January 31, 2004
BVY 04-008

**Subject: Vermont Yankee Nuclear Power Station
License No. DPR-28 (Docket No. 50-271)
Technical Specification Proposed Change No. 263, Supplement No. 5
Extended Power Uprate – Response to Request for Additional Information**

Responses to Request for Additional Information

Figure 7 Dryer Analysis Model

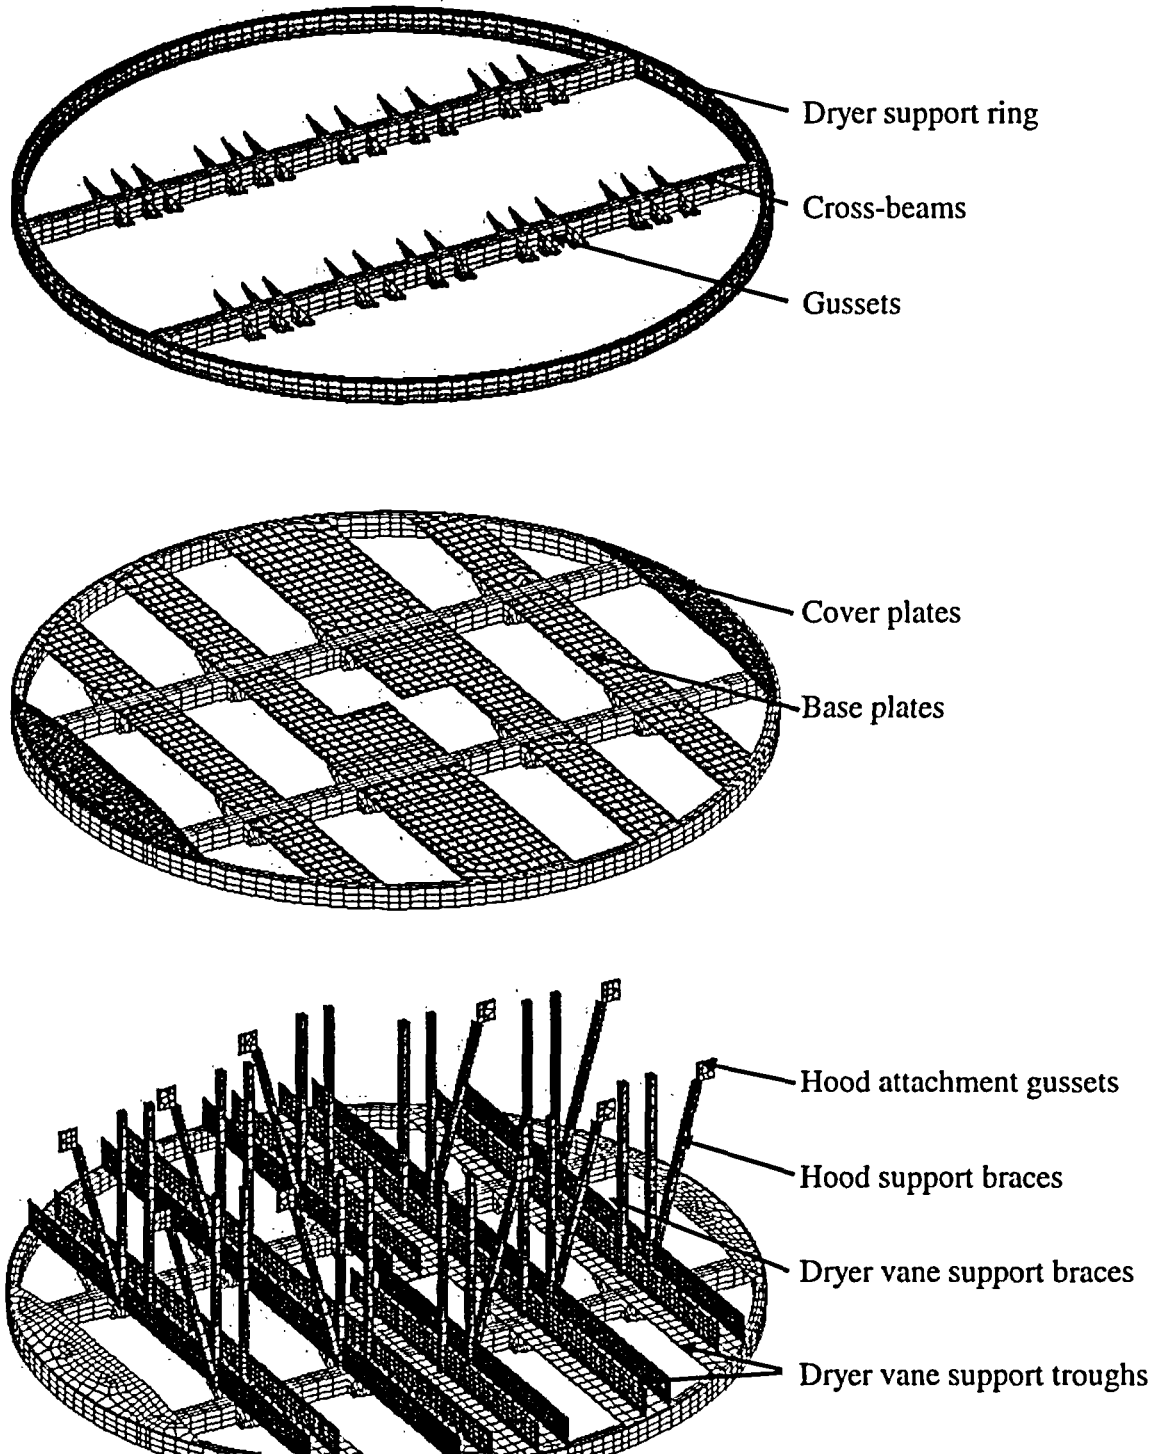
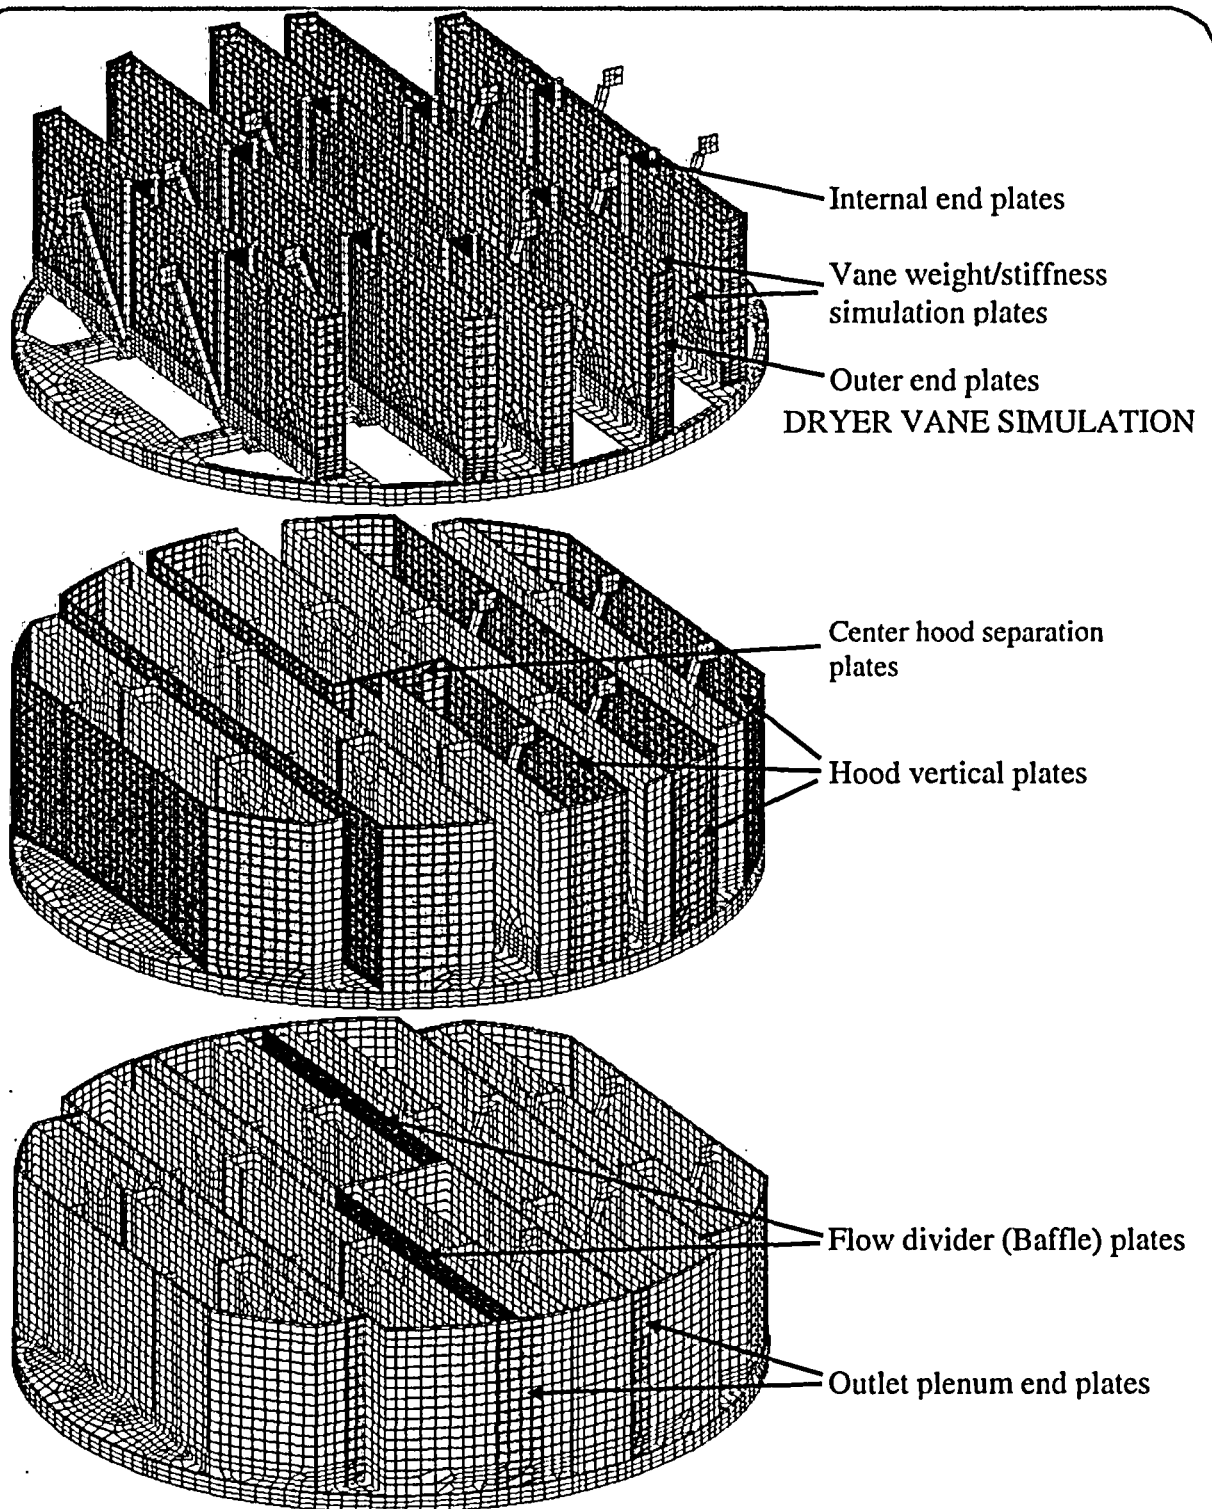
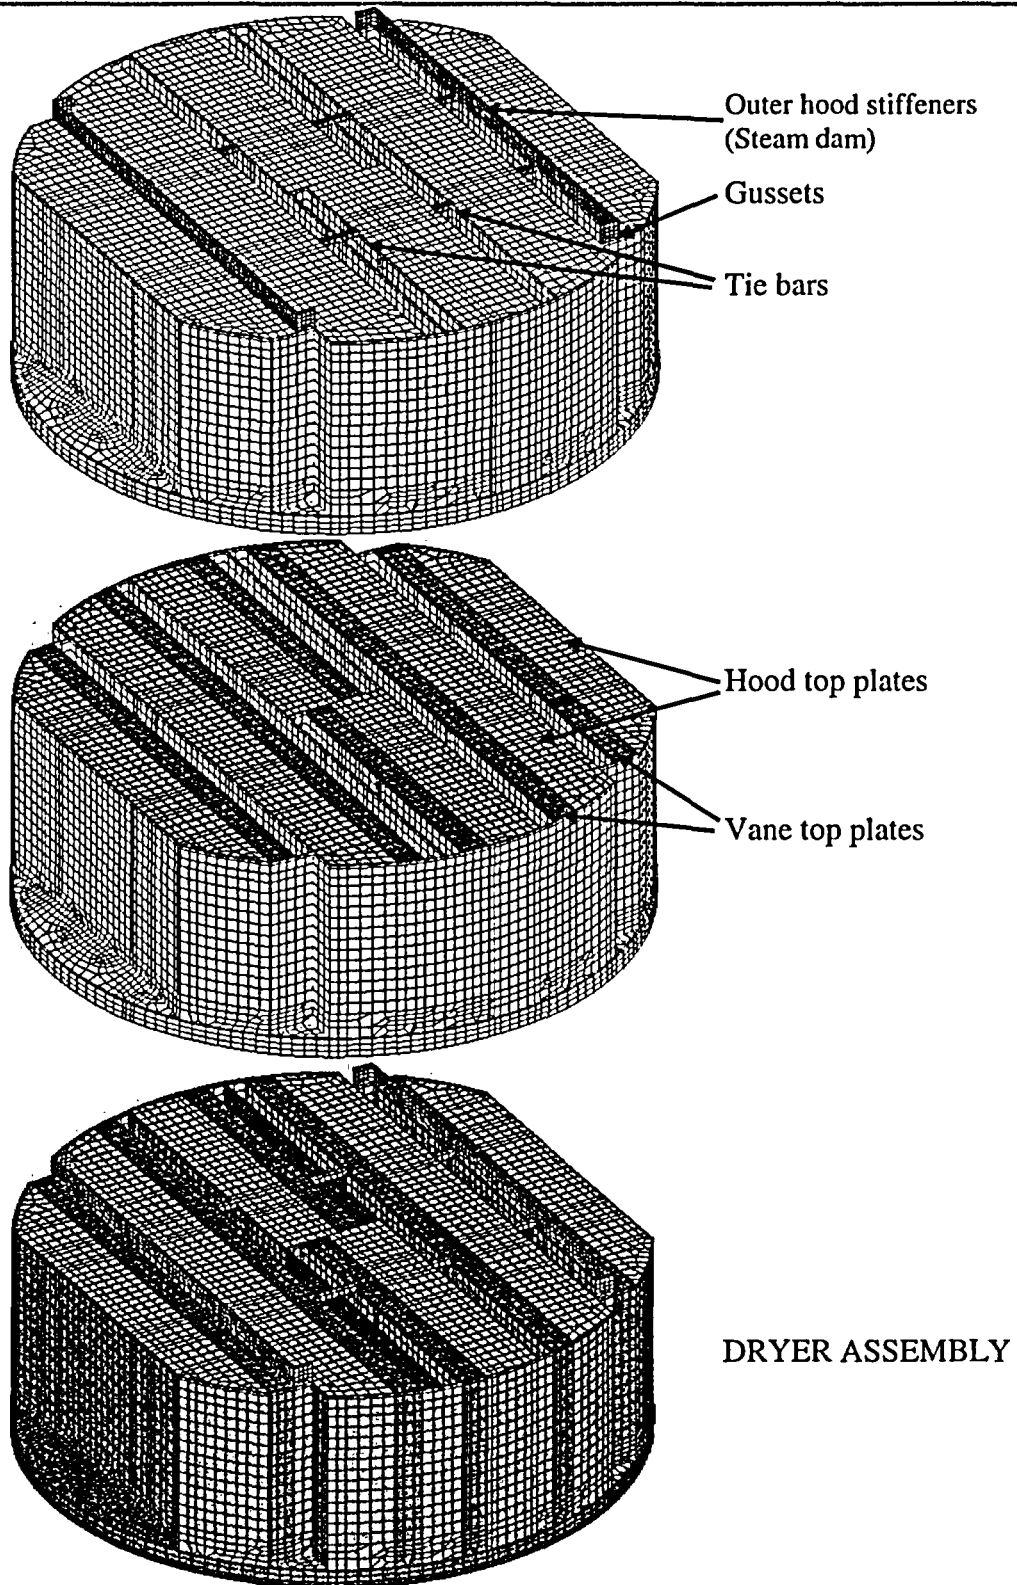
On page 3-15 of Attachment 6 to the submittal dated September 10, 2003, it states that a qualitative evaluation was performed that identified preliminary modifications and inspections to enhance the structural integrity of the steam dryer at CPPU conditions, and that a quantitative evaluation to identify dryer components susceptible to failure at CPPU conditions is being performed. The licensee should describe those evaluations and their results, and the schedule for implementing identified modifications. The licensee should also describe its evaluation of the recommendations in General Electric (GE) Service Information Letter (SIL) No. 644, Revision 1, "BWR Steam Dryer Integrity," and its commitments regarding implementation of those recommendations.

The VYNPS Steam Dryer is a BWR-3 style dryer with internal braces in the outer hoods. For the 120% power uprate application for VYNPS, a quantitative evaluation of the effects of Flow Induced Vibration (FIV) on the steam dryer has been completed to determine modifications that are required prior to CPPU implementation. The following sections describe the process and the quantitative results of the evaluation. Sections 1 through 4 describe the evaluation process and load definition process as applied to VYNPS. Sections 5 through 8 describe the key inputs from design documentation, input assumptions, and quantitative results. Section 9 describes VYNPS actions with respect to GE Service Information Letter (SIL) 644, Supplement 1. Section 10 describes the planned modifications to the VYNPS steam dryer and schedule for modification implementation.

- For Extended Power Uprate, GE has developed a process to evaluate the steam dryer dynamic vibration response. The method is termed "Equivalent Static Analysis Method." The Equivalent Static Analysis Method consists of the following process steps:
 - A Finite Element Analysis (FEA) model of the VYNPS steam dryer was developed (see Section 2). This model was constructed using VYNPS specific dryer dimensions and material properties.
 - The FEA computes steam dryer component natural frequencies and mode shapes (see Section 3).
 - A reference [[]] static pressure load is applied in the FEA model. Steam Dryer component Membrane (Pm) and Surface (Pm + Pb) stresses are computed from the [[]] reference load.
- Dynamic loading on the steam dryer components is computed via the following equation:
$$DL = (Pm+Pb) \times (FIV \text{ Load rms}) \times (P) \times (AF) \times (C)$$

Figure 2

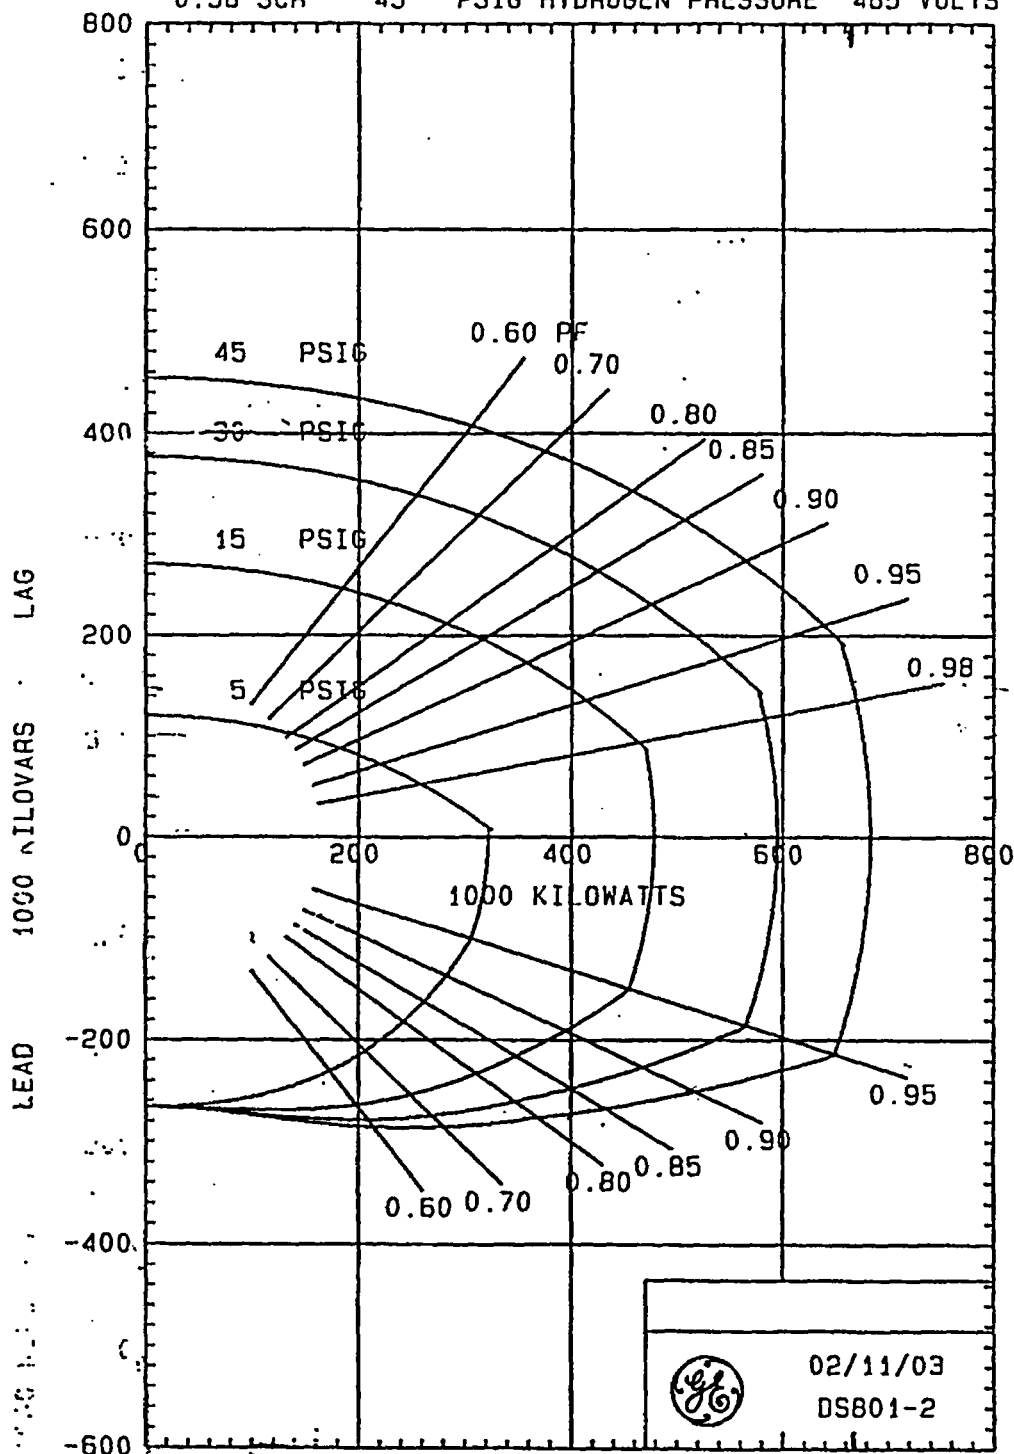
The existing VY Generator is rated 626 MVA. The nominal gross output of Vermont Yankee is currently about 550 MWe. The existing generator VAR capability at rated output corresponding to a 550 MWe output is approximately 330 MVAR; however, VY experiences increased Turbine Generator vibration at MVAR loading greater than 150 MVAR. The vibration is related to uneven heating of the generator rotor at increased field current. The existing generator capability curve and the existing operating point are attached. [See Attachment 3, Exhibit 1, Figure 1] VY has historically reported its reliable MVAR output as 150 MVAR and has used this value in all transmission system studies.

The rewound VY generator will be rated 684 MVA at 0.969 pf. The revised capability curve is attached. [See Attachment 3, Exhibit 1, Figure 2] During the 2004 refueling outage the existing rotor is being re-insulated. The re-insulation of the rotor should remove the existing 150 MVAR output limit. Under CPPU conditions the nominal generator output is analyzed in the System Impact Study to be as high as 667 MWe. At this output, generator MVAR capability would remain at the pre-uprate capability of 150 MVAR.
